Manual Supplement

Manual Title:	2640A/2645A NetDAQ Service	Supplement Issue:	4
Part Number:	942615	Issue Date:	7/09
Print Date:	March 1995	Page Count:	8
Revision/Date:

This supplement contains information necessary to ensure the accuracy of the above manual. Enter the corrections in the manual if either one of the following conditions exist:

Figure A.

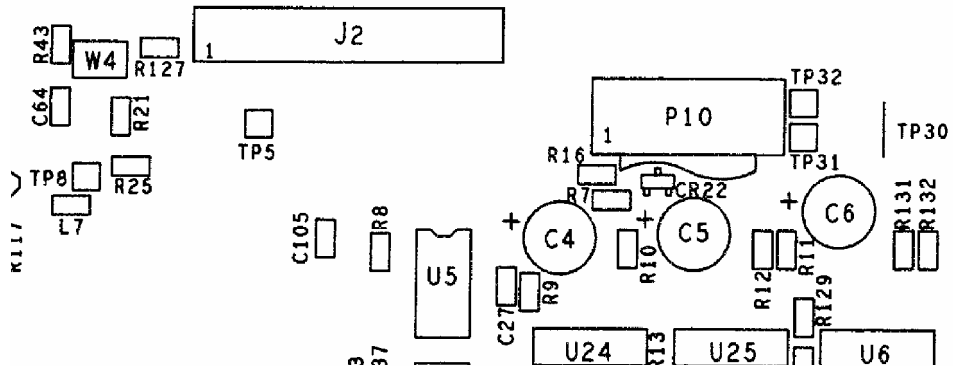
On pages 6-14 and 7-3, Figures 6-2 and 7-1, add C105 as shown in Figure A.

Figure B.

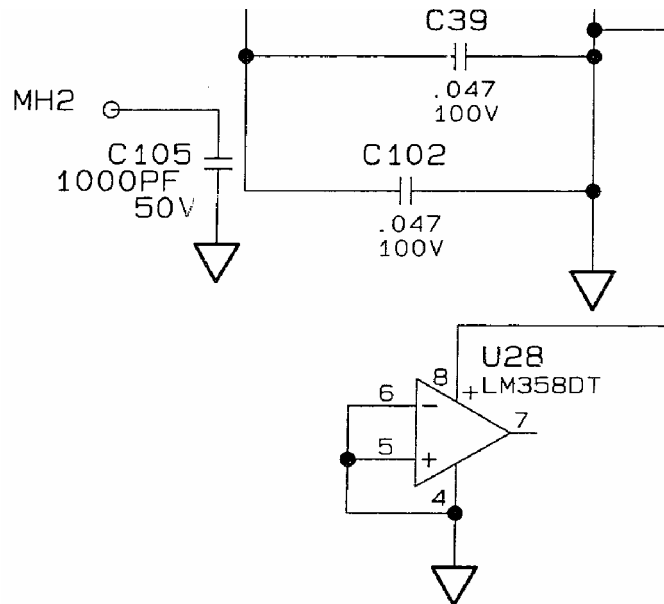
On page 7-4, Figure 7-1, add C105 as shown in Figure B.

Figure 4-1. Performance Test Setup

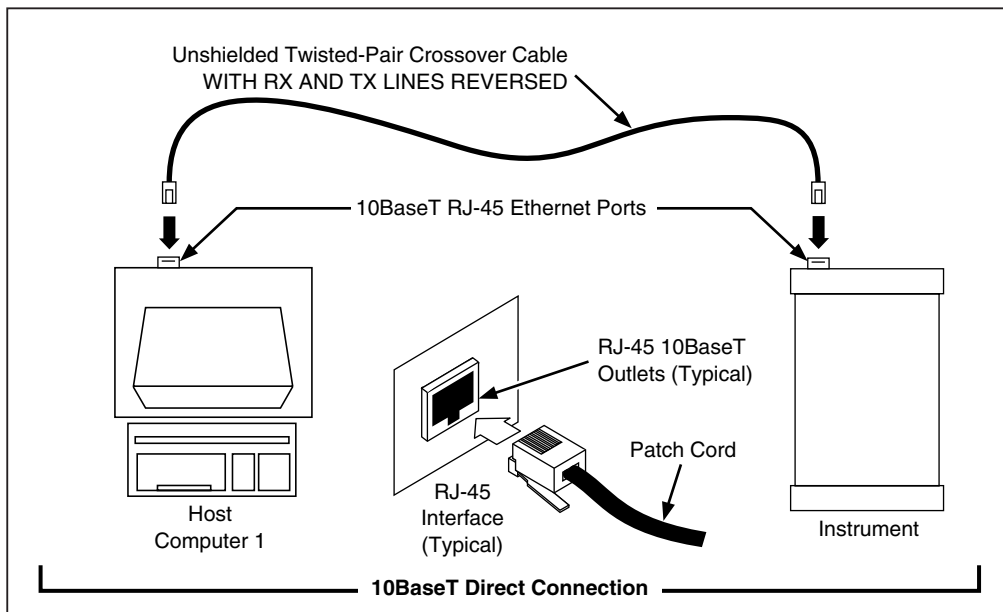
The 10Base2 Ethernet port has been eliminated on the 2640A and 2645A. Any reference to the 10Base2 or coaxial network connections should be disregarded.

On page 4-3, under **Configuring the Performance Test Setup** replace step 1 with the following:

1. **Connect the Instrument and Host Computer** Make the network connections to the instrument and the host computer using a suitable RJ45 UTP Crossover cable as shown in Figure 4-1.

On page 4-5, replace Figure 4-1 with the following:

Figure C

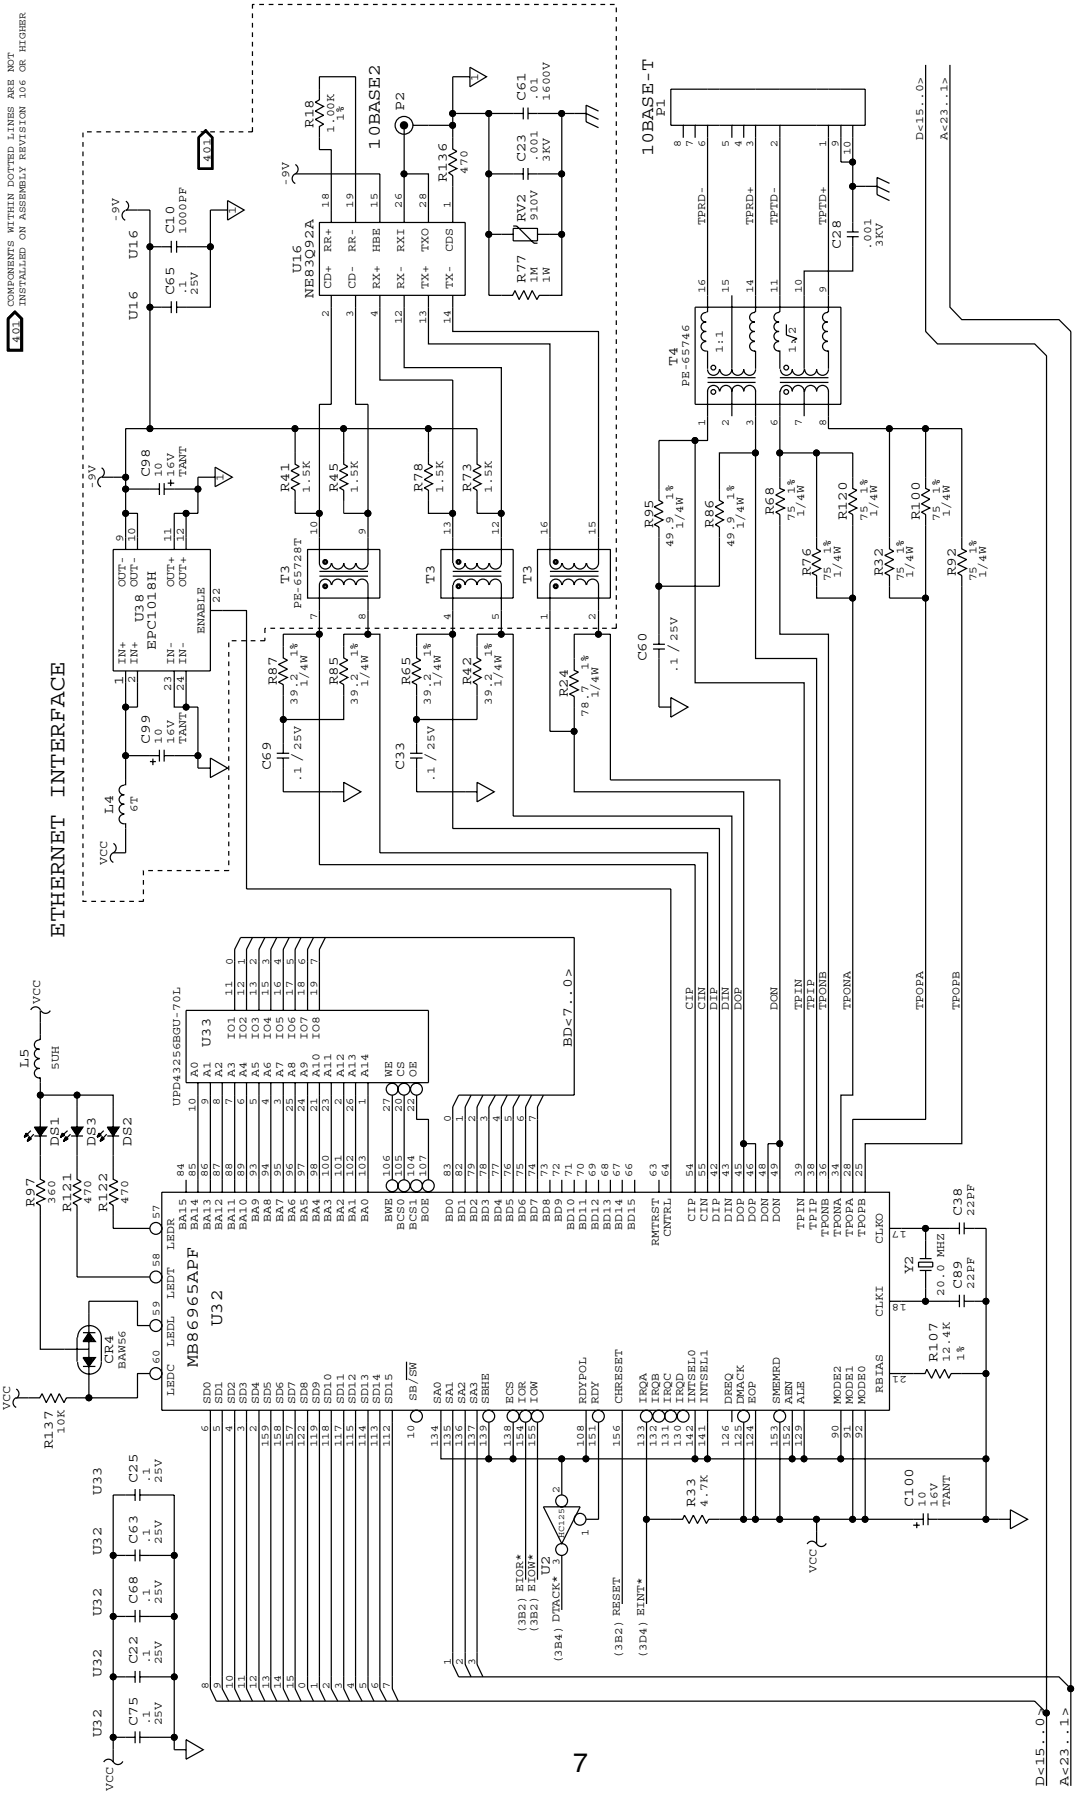
On pages 6-14 and 7-3, Figures 6-2 and 7-1 delete the C10,C65, L4, P2, R18, R41, R45, R73, R78, T3, U16 and U38 from the component location drawing.

On page 7-6, Figure 7-1, replace sheet 4 of the schematic with Figure C.

COMPONENTS WITHIN DOTTED LINES ARE NOT INSTALLED ON ASSEMBLY REVISION 106 OR HIGHER
